**DESIGN REVIEW BOARD AGENDA
NOTICE OF MEETING**

TITLE: <p style="text-align: center;"> DESIGN REVIEW FILE: DESIGN-2019-23-SEPTEMBER-6a 60-68 DORCHESTER ST OWNER: GENDUST CO LTD. APPLICANT: DUNSTAN CARROLL </p>		 CHARLOTTETOWN
MEETING DATE: September 23, 2019		Page 1 of 3
DEPARTMENT: Planning & Heritage	ATTACHMENTS: A. Design Review Submission (September 17, 2014) B. External Design Reviewer Comments (October 5, 2014) C. Revised drawings	
SITE INFORMATION: Ward No: 1 Queen's Square Existing Land Use: Vacant Property Official Plan: Downtown Neighbourhood Zoning: Downtown (DN) Zone

RE: DESIGN REVIEW: DORCHESTER ROW HOUSES

2.5 Elevations

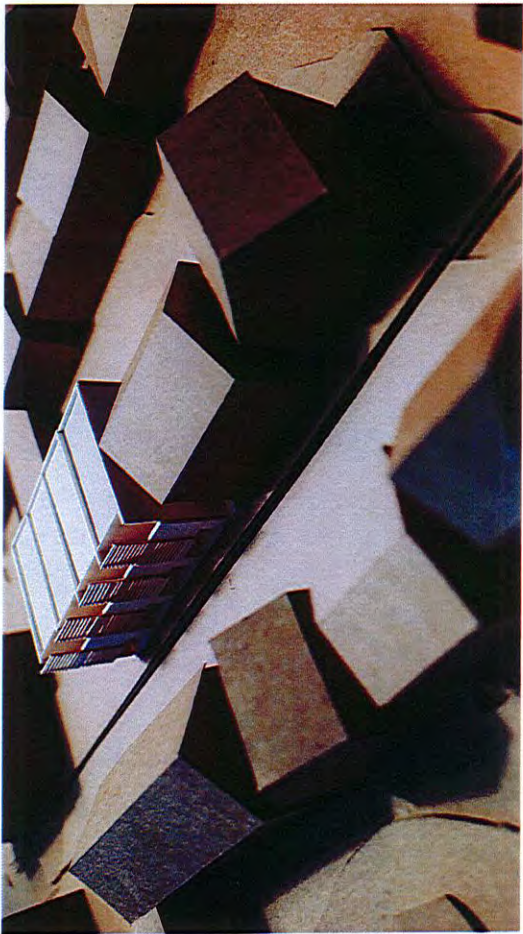
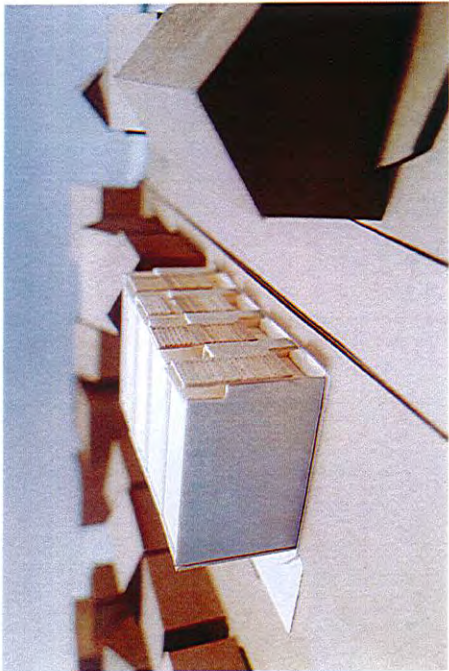
1. Several minor discrepancies were noted between the floor plans and the elevations presented in the applicant's submission, such as an indication of a shower on the third floor plan projecting past the plane of the setback façade, whereas the elevation does not illustrate this volume. Based on our conversation with the applicant, it is assumed for the purposes of this review that the elevations presented in their submission are correct.

3. The various design models and contextual images illustrated in the applicant's submission do not show or appear to consider the impact of rooftop occupancies in relation to adjacent buildings. These can be supported in theory; however, their contextual impact should be better understood before proceeding.

As shown on page 22 of the applicant's submission, the rooftop occupancy begins at a height extending above the neighbouring context and it is assumed from the elevations that the proposed rooftop deck railing sits on the same plane as the primary building façade. Given this, the materiality and transparency of the railing must be reviewed so as to not read as though the building façade is higher than what relates to the size and scale of the neighbourhood. Although the proposed façade design steps back to acknowledge the neighbours, it must be recognized that the roof planes of the historic buildings on the street step back from the street at a much greater rate and, therefore, the proposed townhouses already have an increased street presence at the third floor line.

- 1.1. In the event that any revisions to the elevations and building envelope are required, these revisions should be made subject to the design review process for comments.

- 3.1. The rooftop railing material must have a high degree of transparency, such as glass or thin metal wire or similar materials
 - 3.2. Alternately, the rooftop railing must be sufficiently set back from the façade so as to not be visible from the sidewalk on the opposing side of the street.
4. The applicant has provided little analysis of the rooftop stair enclosure in their submission, however, its appearance from the street and from various view planes may have an effect on the developments perceived bulk in relation to the surrounding context. Of particular interest is the end unit closest to Pownal Street where the side yard façade could have an appearance of being 4 storeys tall and well above the adjacent property.

1 NORTH ELEVATION
 SCALE: 1/4" = 1'-0"

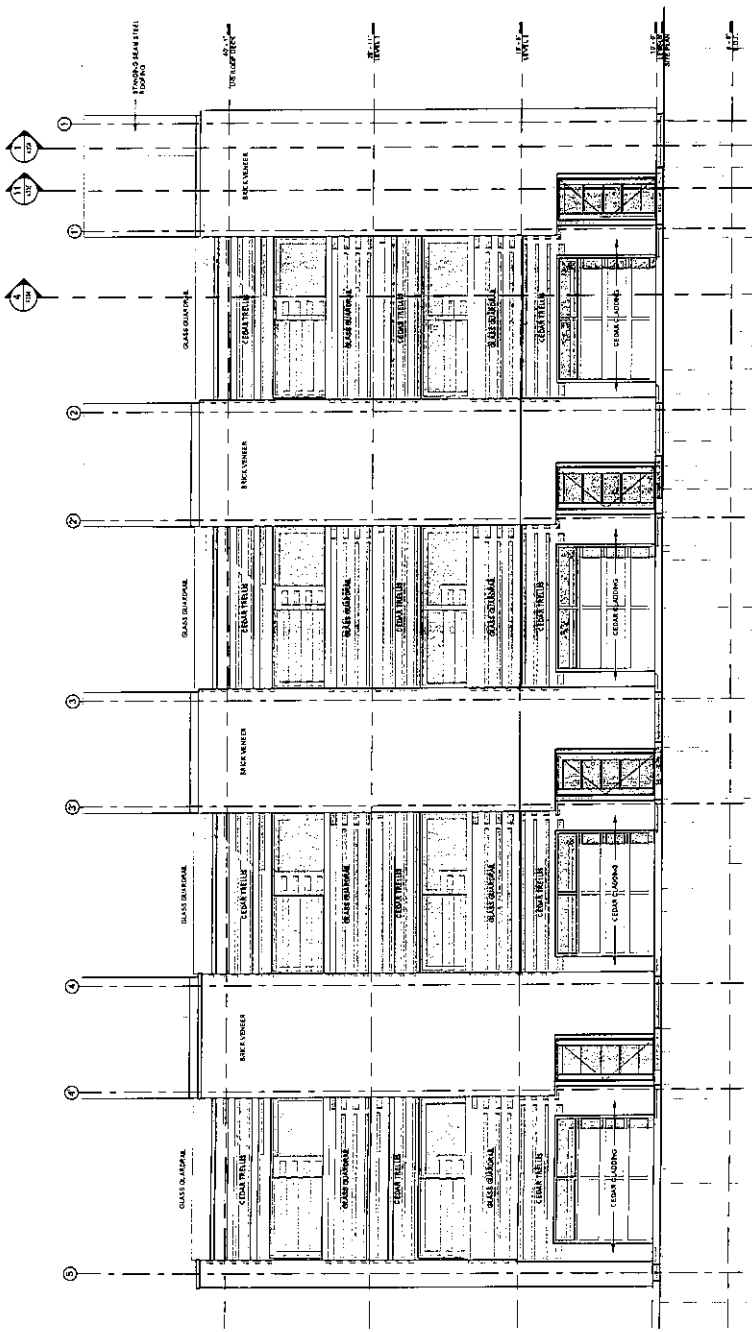
- 1) The front façade was originally to be clad in wood siding. The drawings have changed to incorporate a combination of a dark brick and wood siding.

2 WEST ELEVATION
 1/2" = 1'-0"

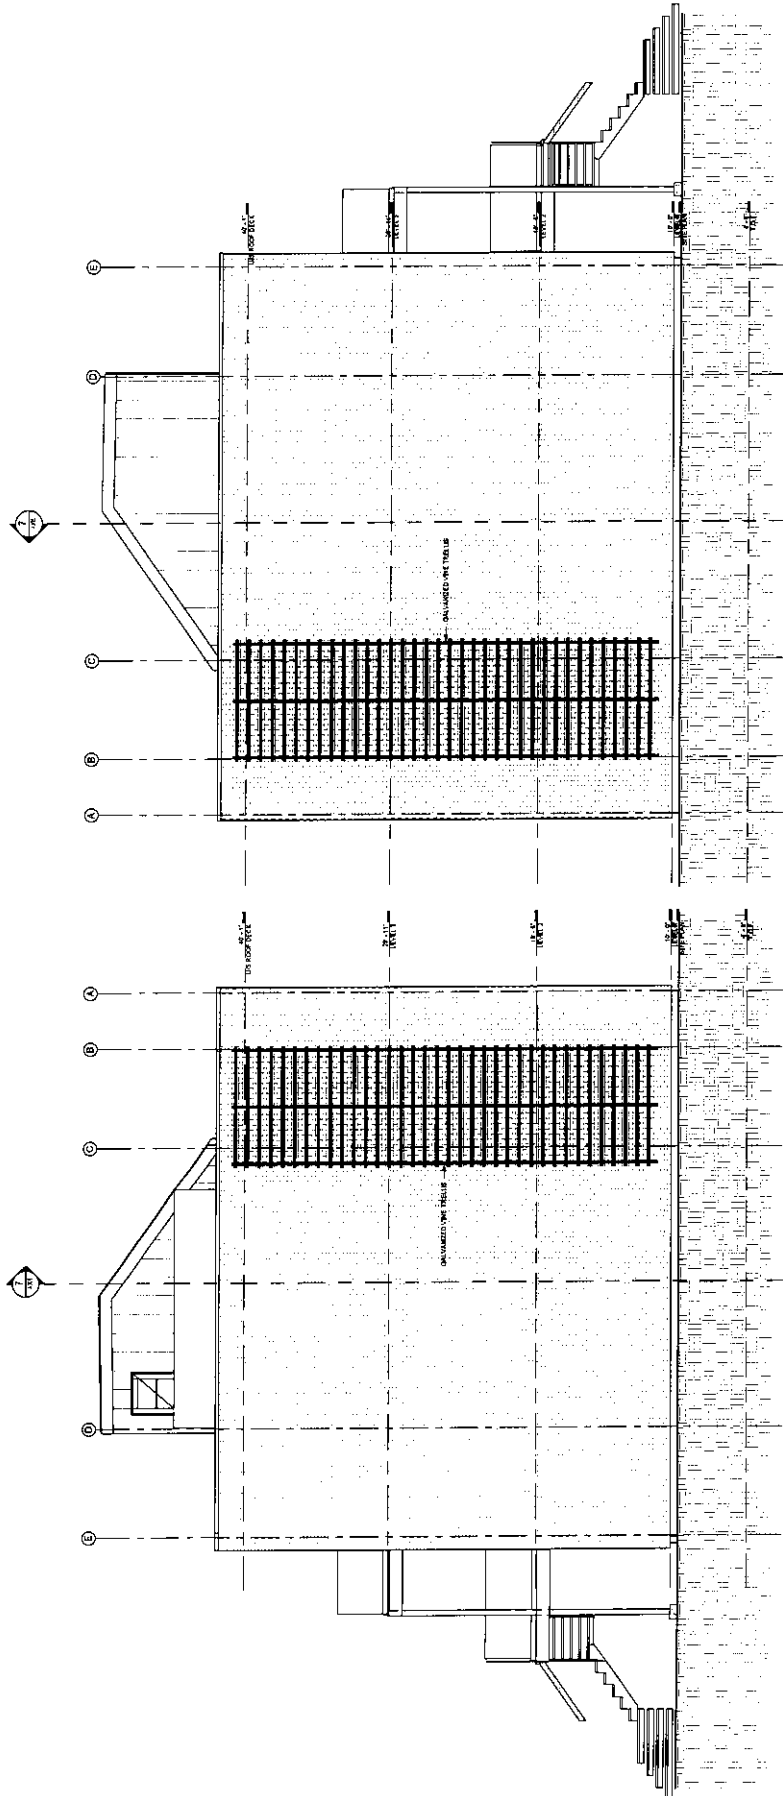
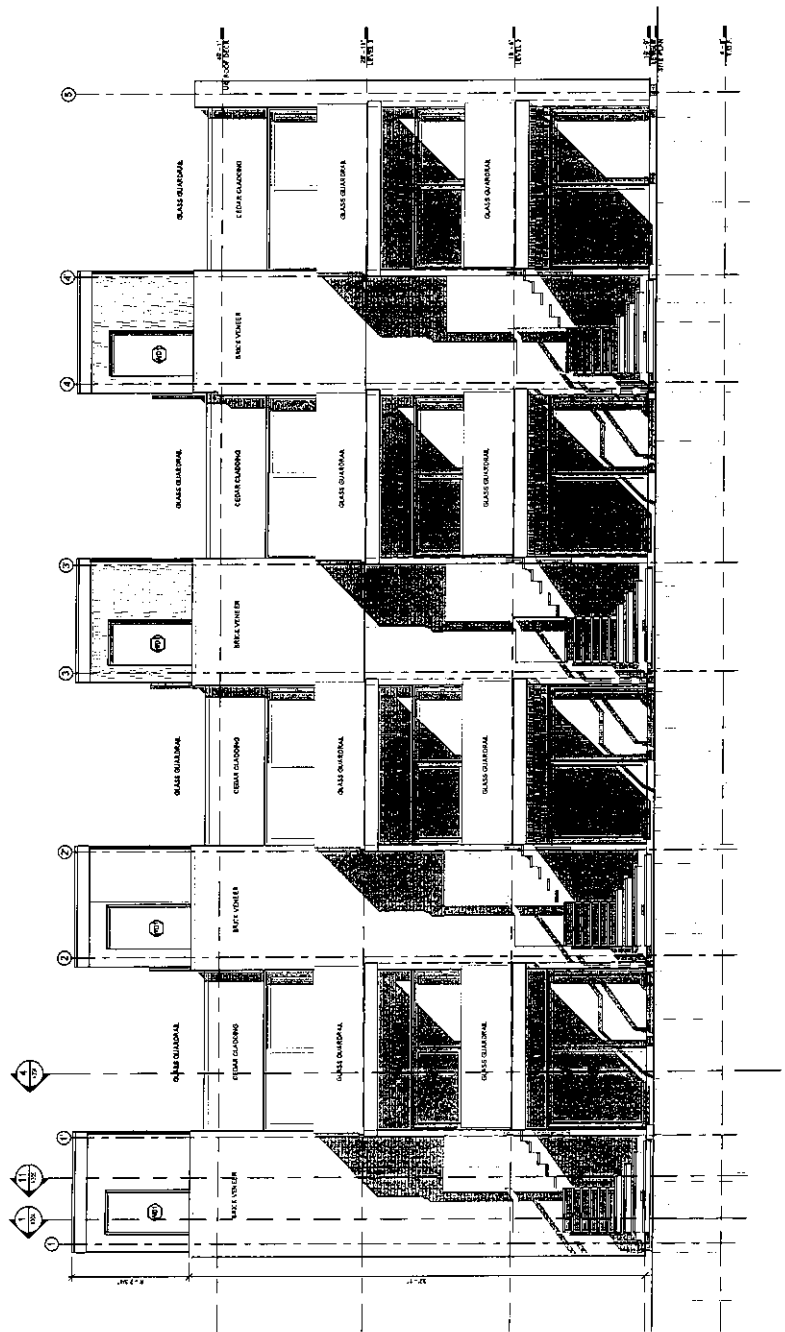
- 2) The side elevations were originally to be clad in a metal siding that would run horizontal with a wood trellis over the siding. The applicant has decided to clad the side elevations with brick and a metal trellis over the brick.

- 4) The trellis on the front façade of the building appears to be similar to the original proposal however it does not wrap the corners like originally proposed. The side trellis now is comprised of metal and has been placed mainly to facilitate the growth of climbing vines.
